## **GAROB DEVELOPMENTS LIMITED**

### **PROPOSED CHANGE OF USE, FROMER CO-OP, WELL STREET, CEFN MAWR, WREXHAM**

#### **TN03 – RESPONSE TO LHA COMMENTS**

**12<sup>TH</sup> JULY 2023**

title  
PROPOSED SITE LAYOUT  
SWEEP PATH ANALYSIS  
FTA DESIGN 10M RIGID VEHICLE

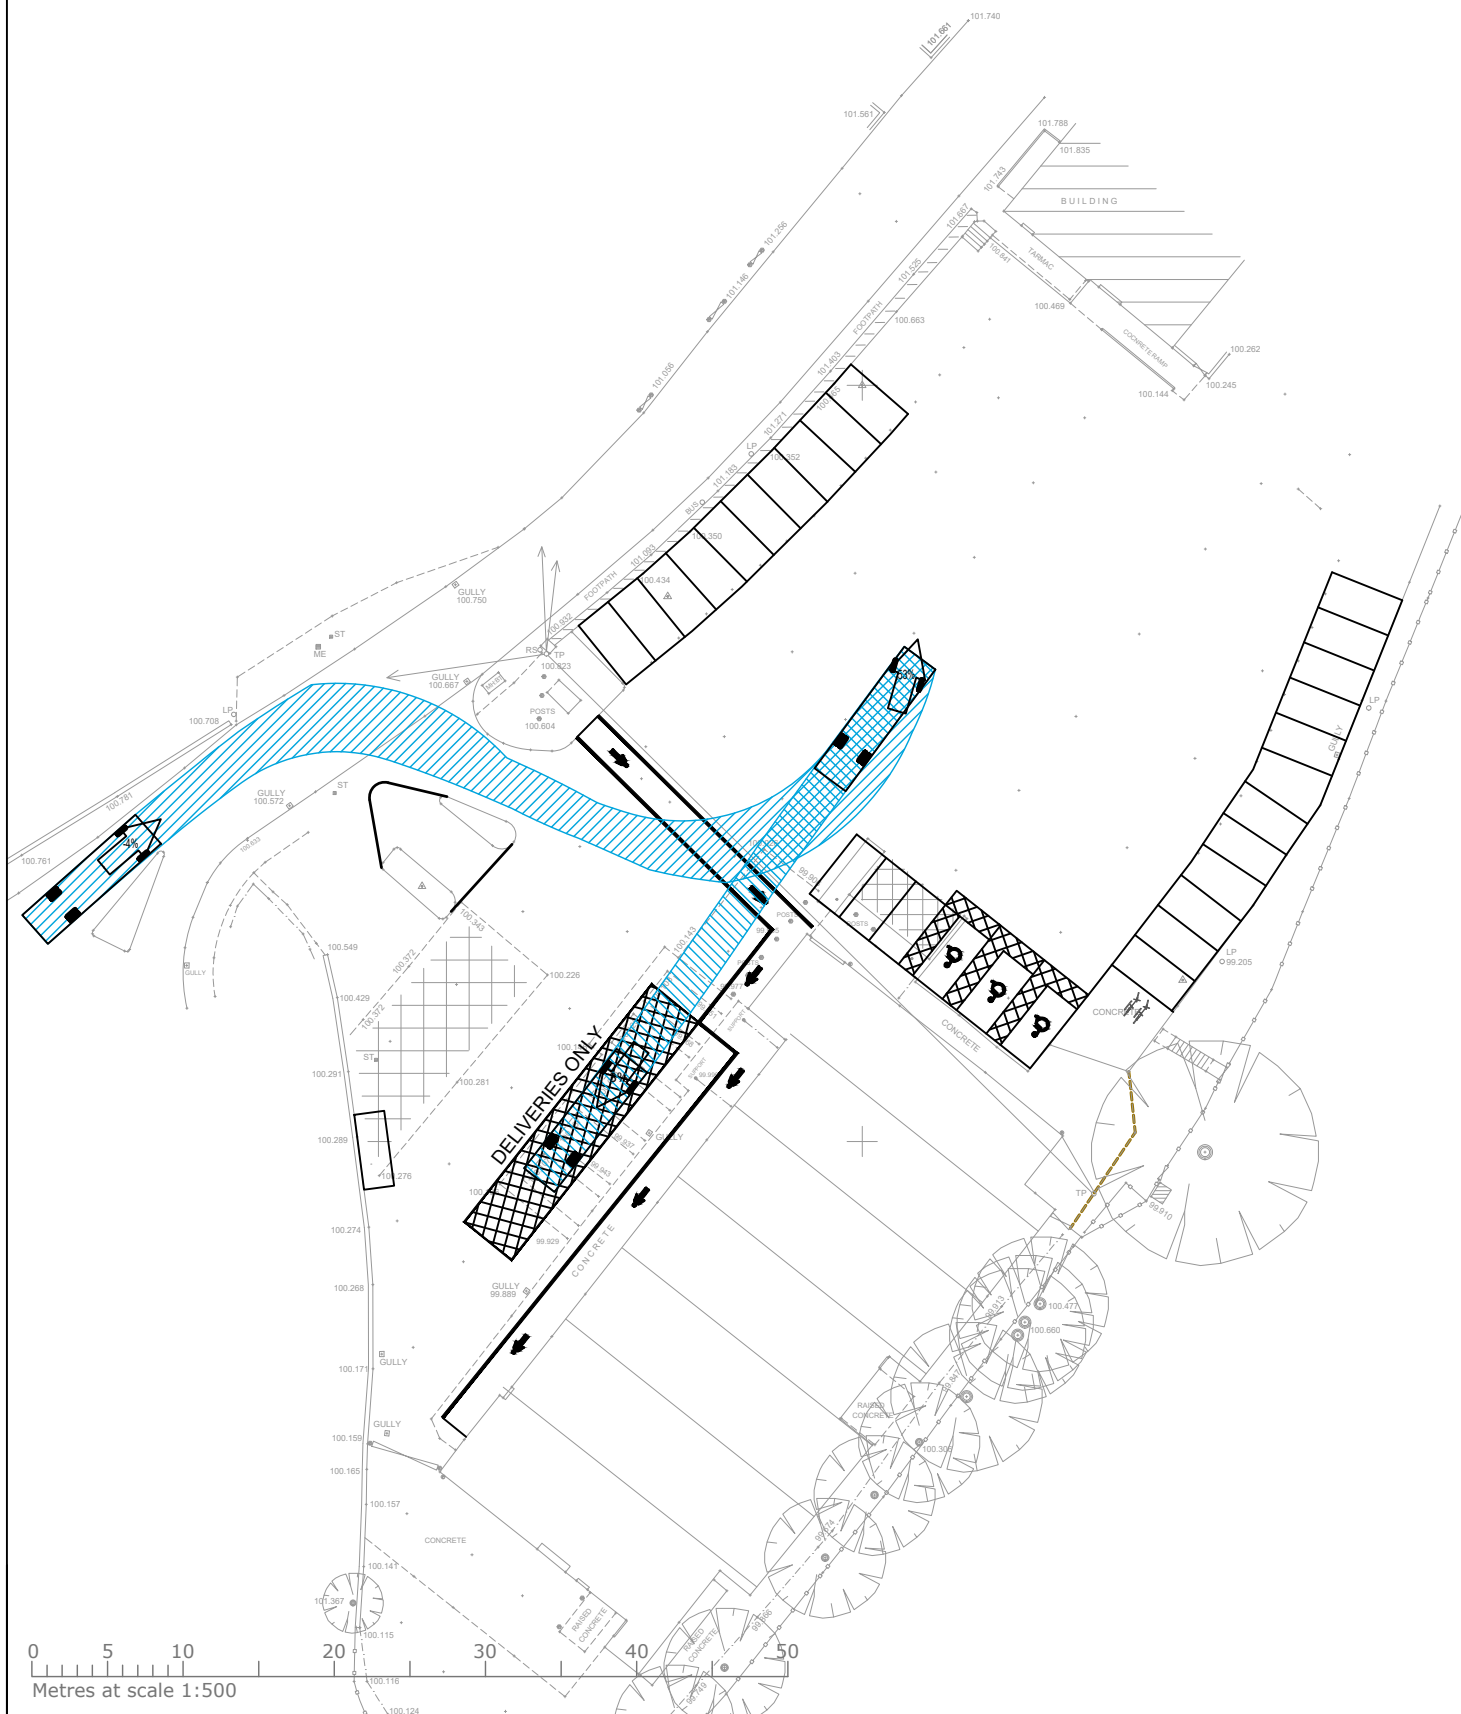
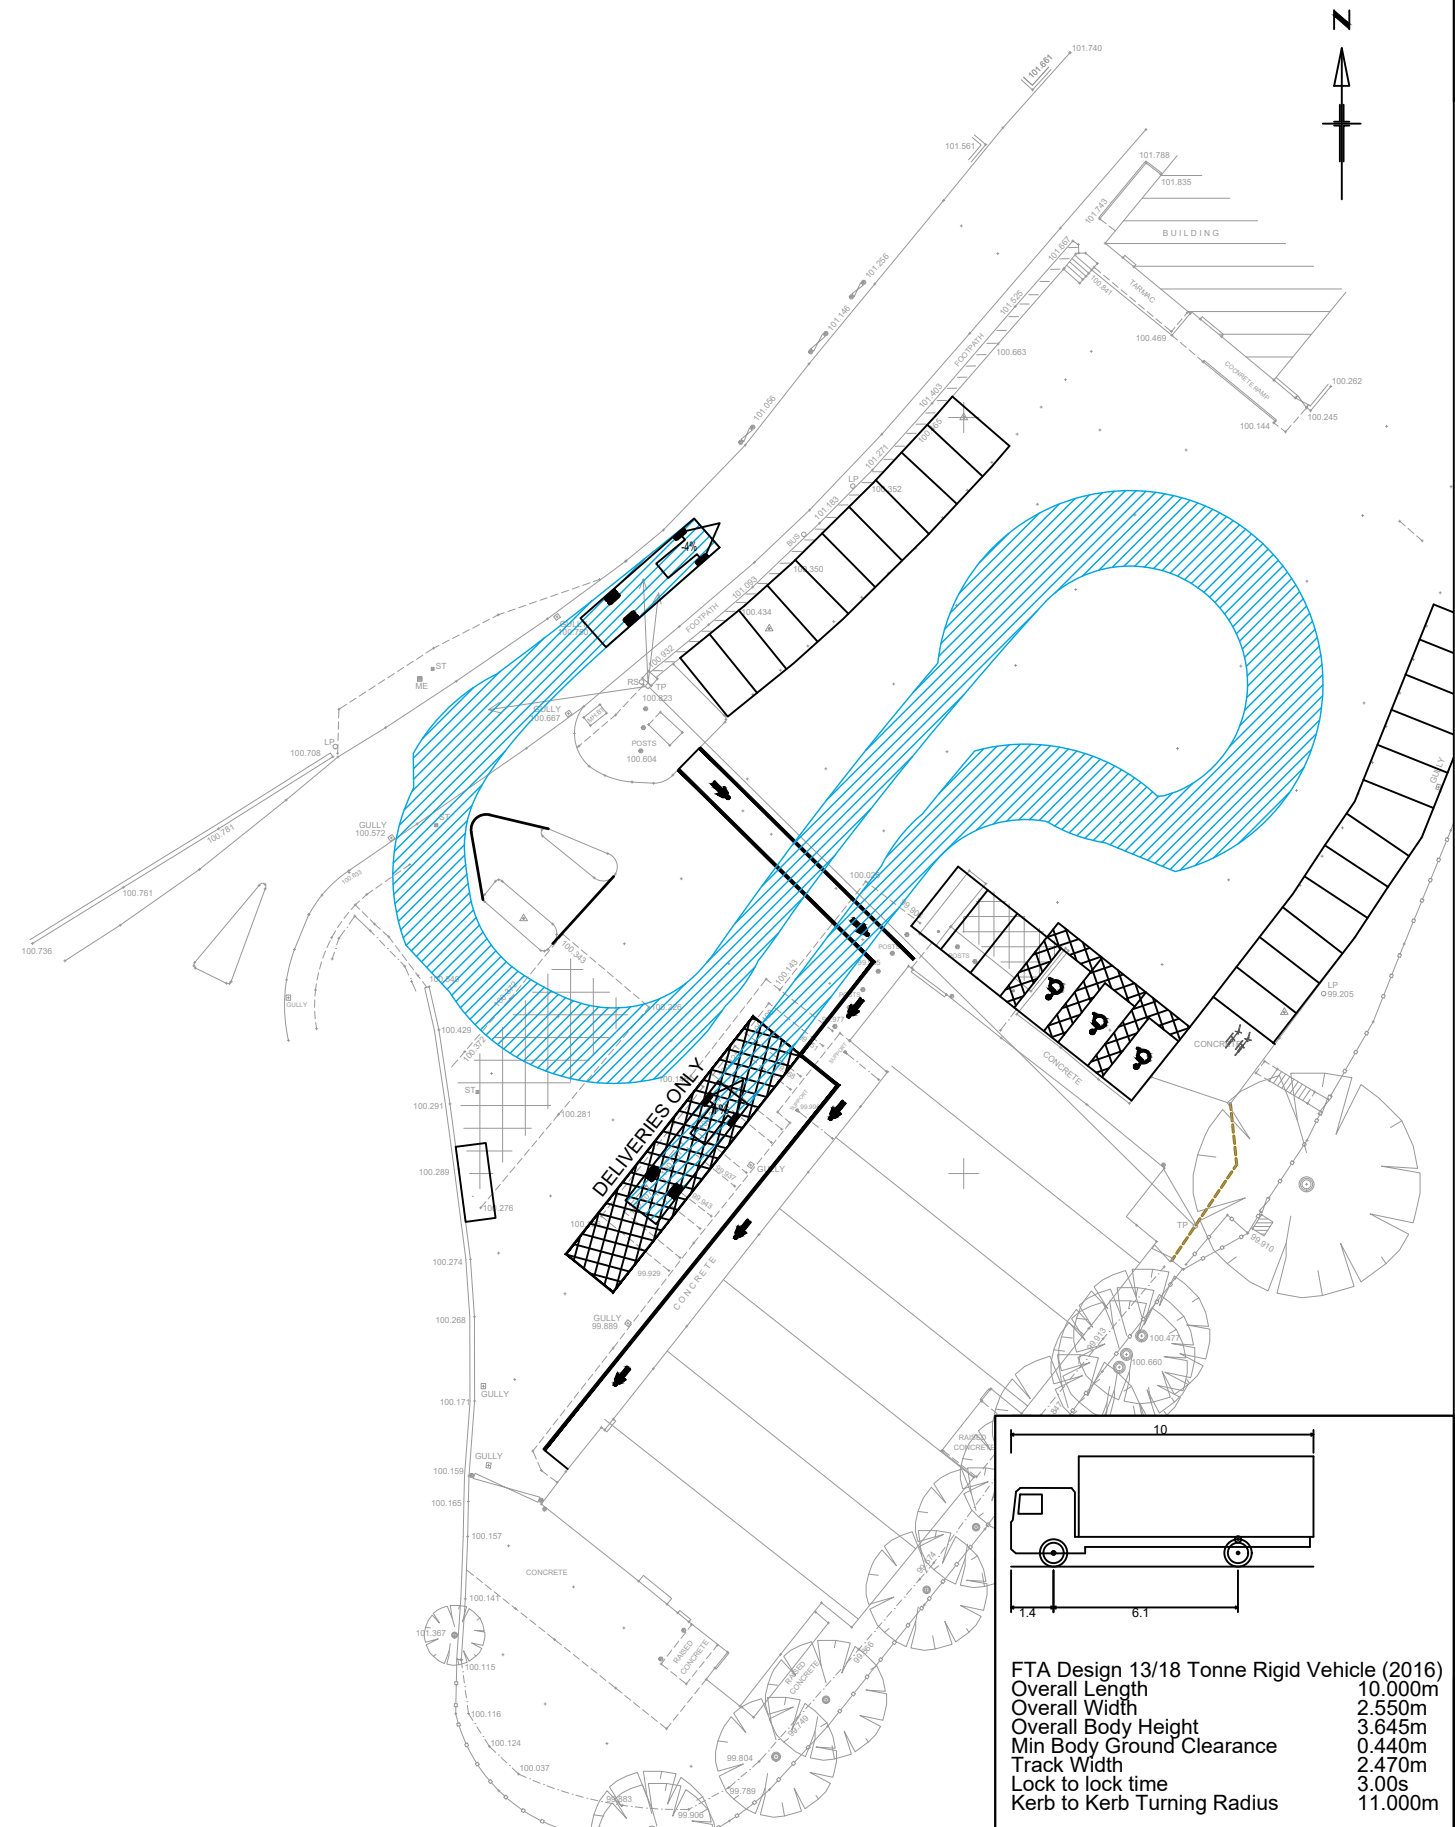
*2. Deliveries and servicing of the proposed premises*

- 4.6 A marked dedicated delivery and servicing area will be situated fronting the western side of the building. The swept path analysis at Appendix 2 demonstrates that 16.5m articulated and 10m rigid vehicles are able to manoeuvre within the site.

title  
PROPOSED SITE LAYOUT  
SWEEP PATH ANALYSIS  
REFUSE VEHICLE

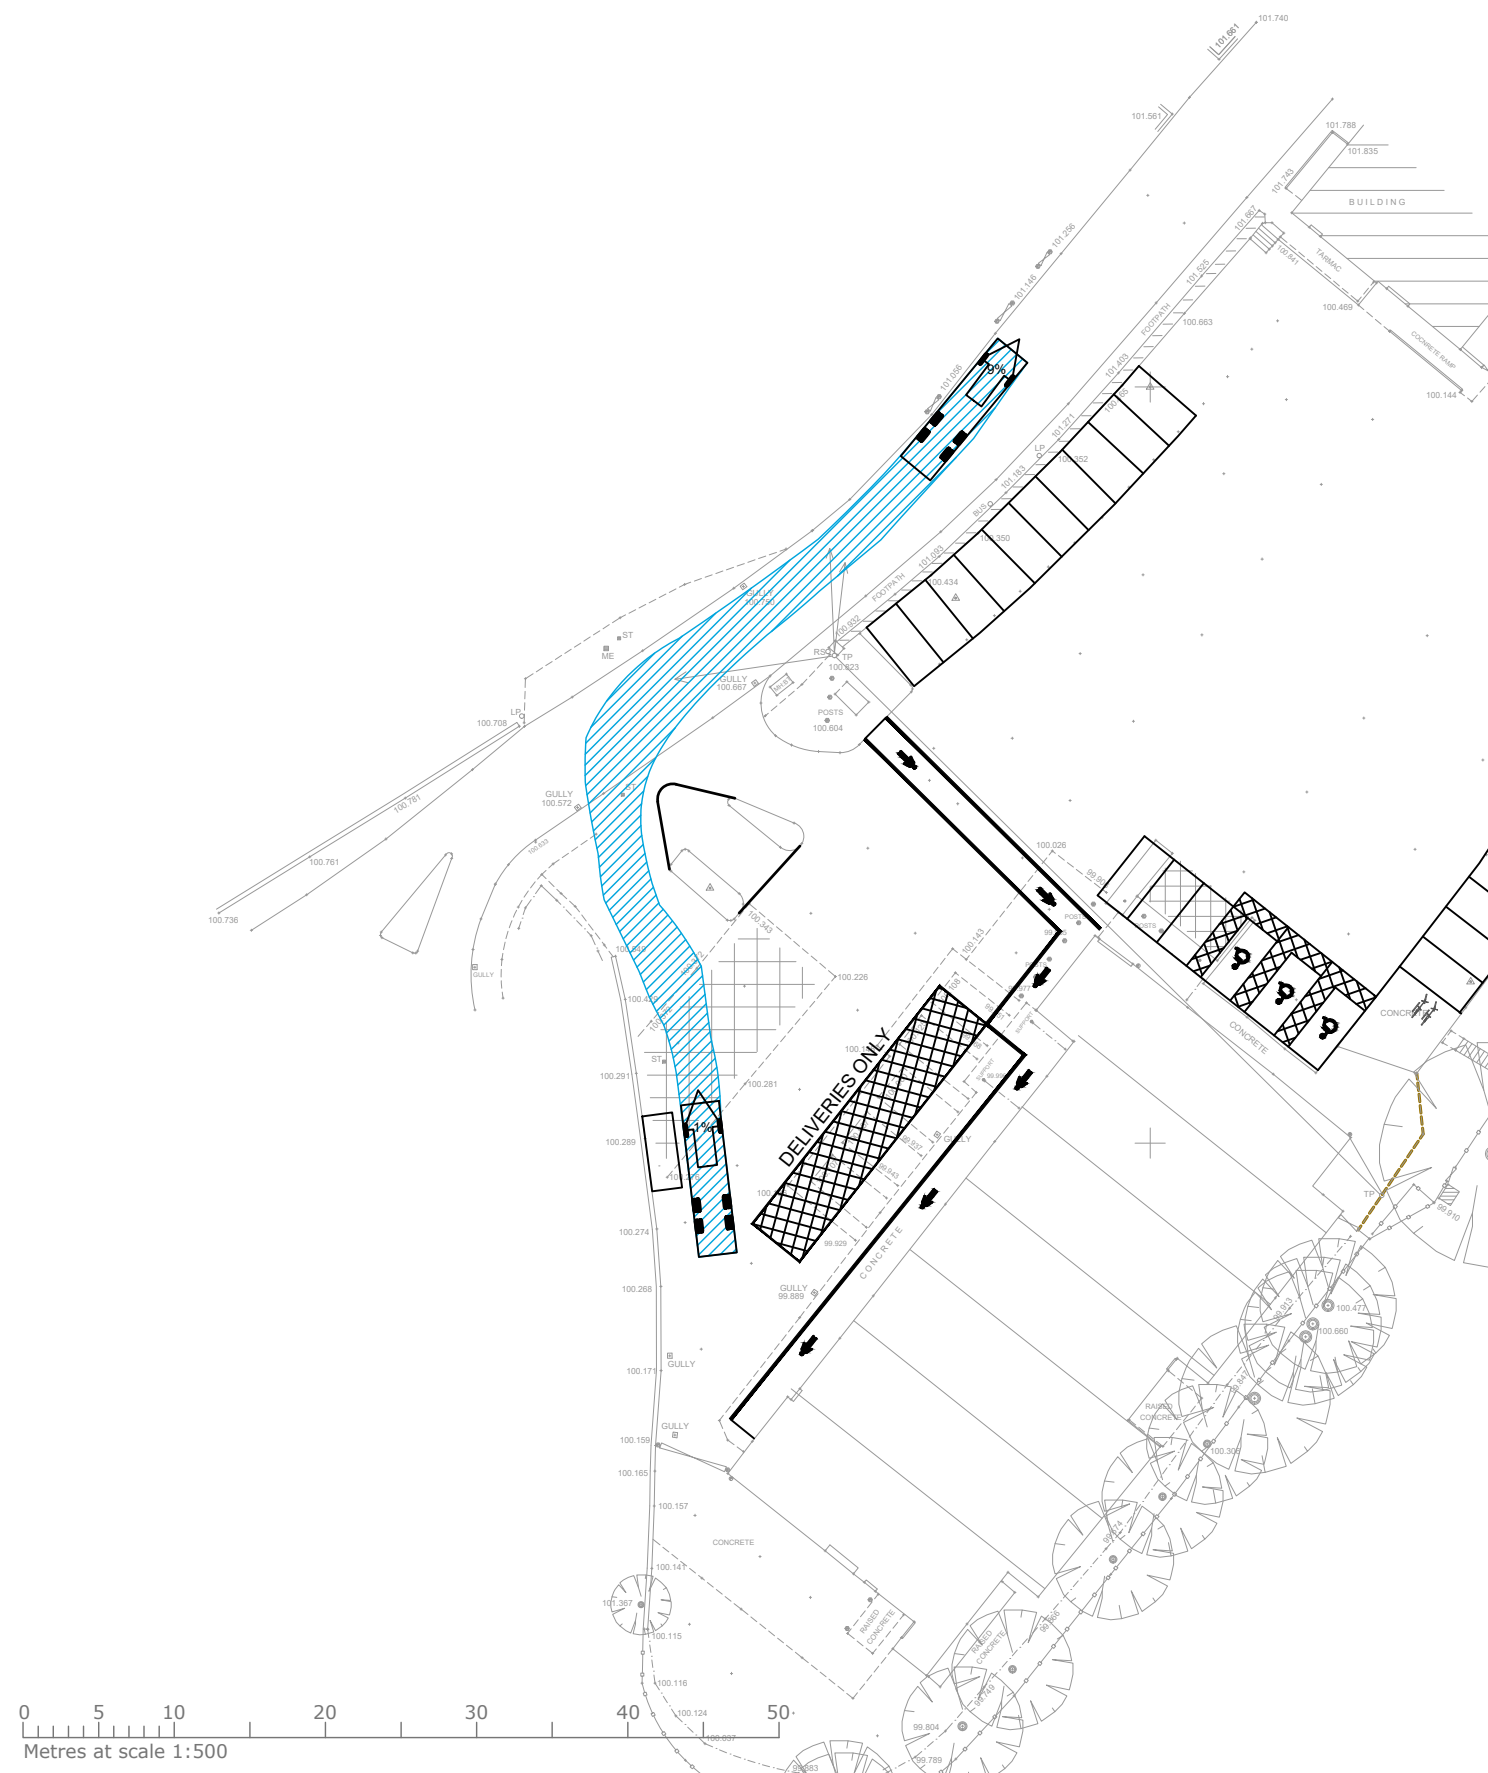
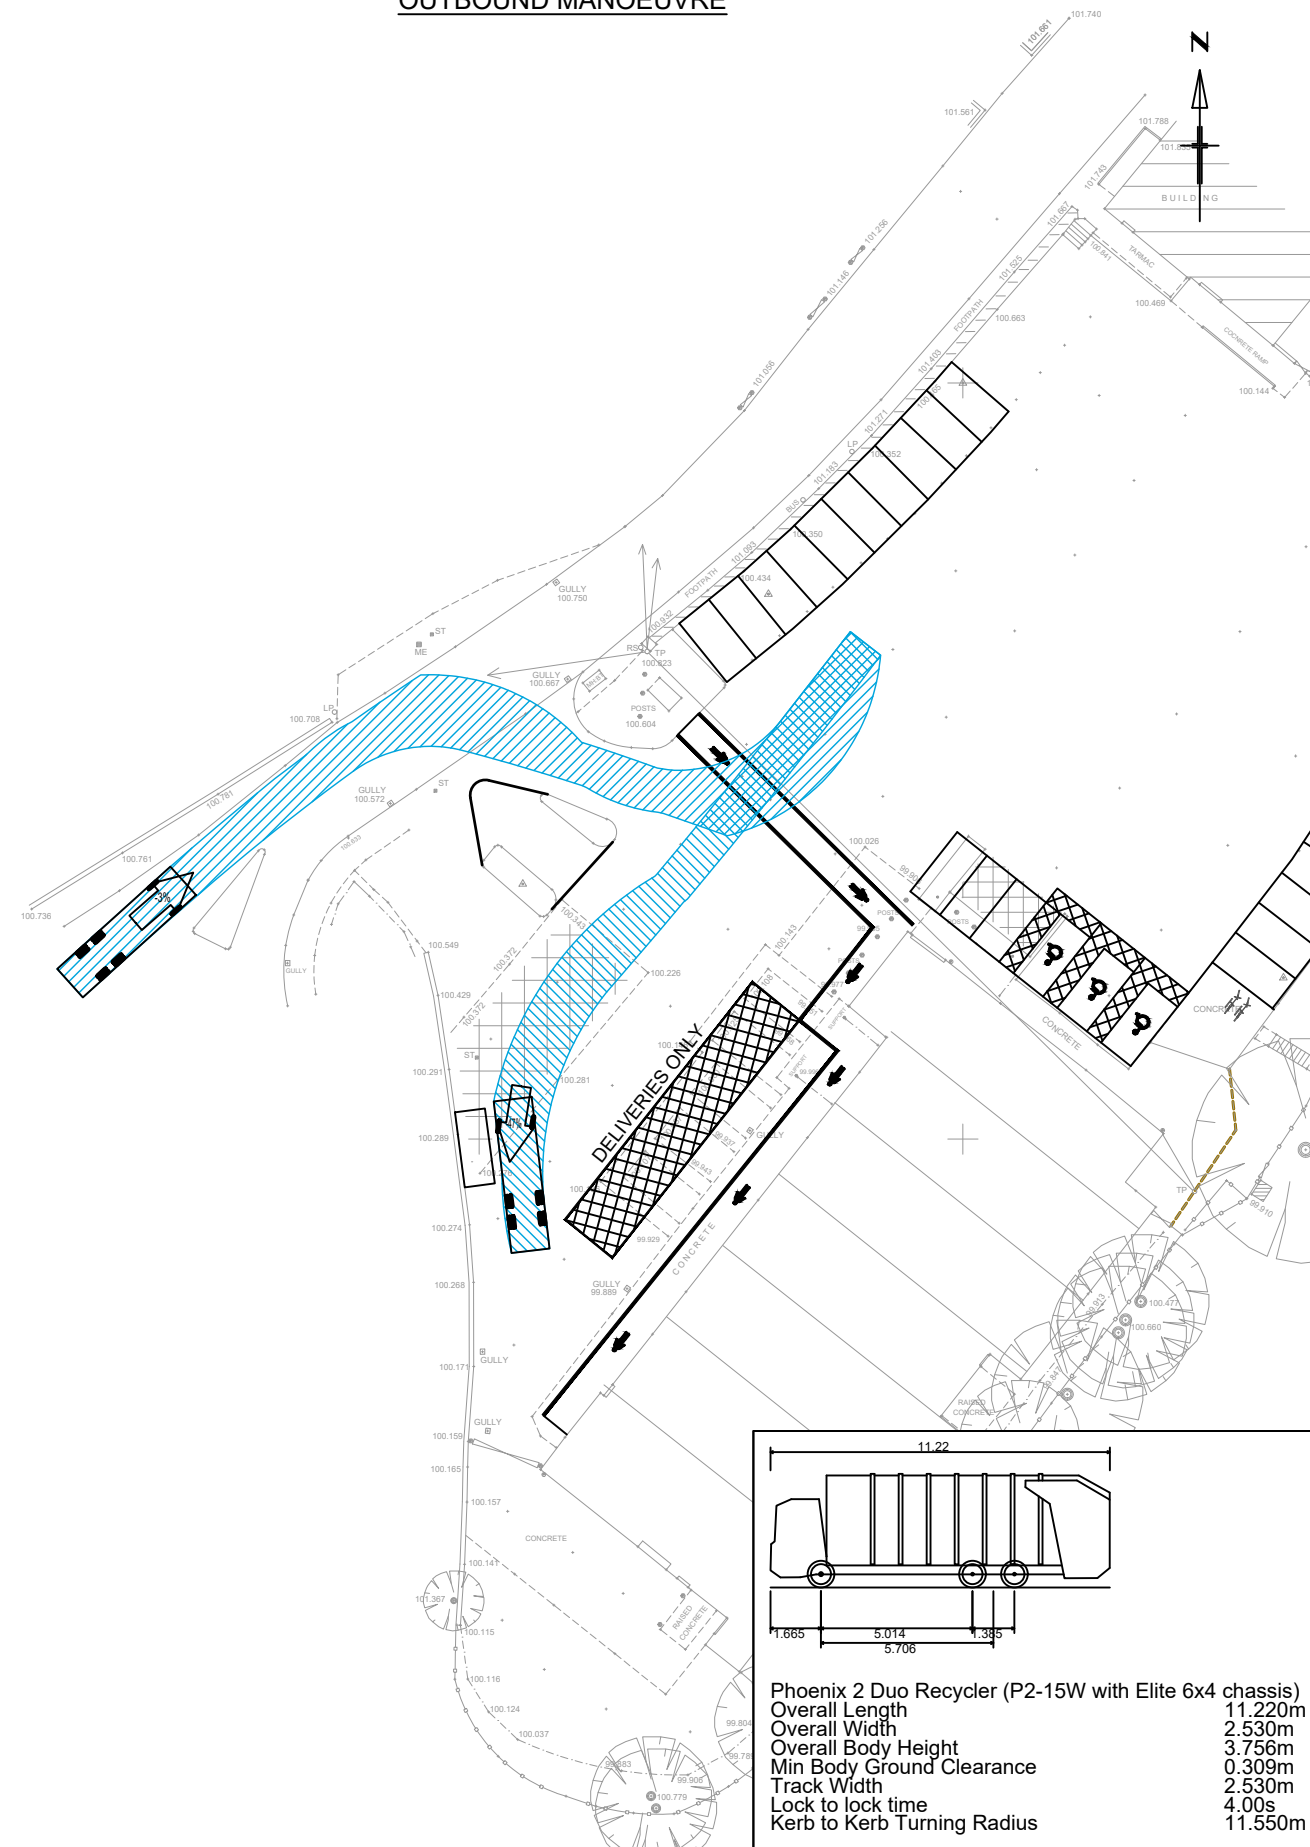
*5. Refuse Collection*

- 4.9 Refuse collection is proposed to take place within the site at the refuse collection point on the southern boundary of the site, which is identified on the proposed site plan. Refuse vehicles will be able to manoeuvre within the site to undertake this, which is demonstrated by the swept path analysis at Appendix 2.
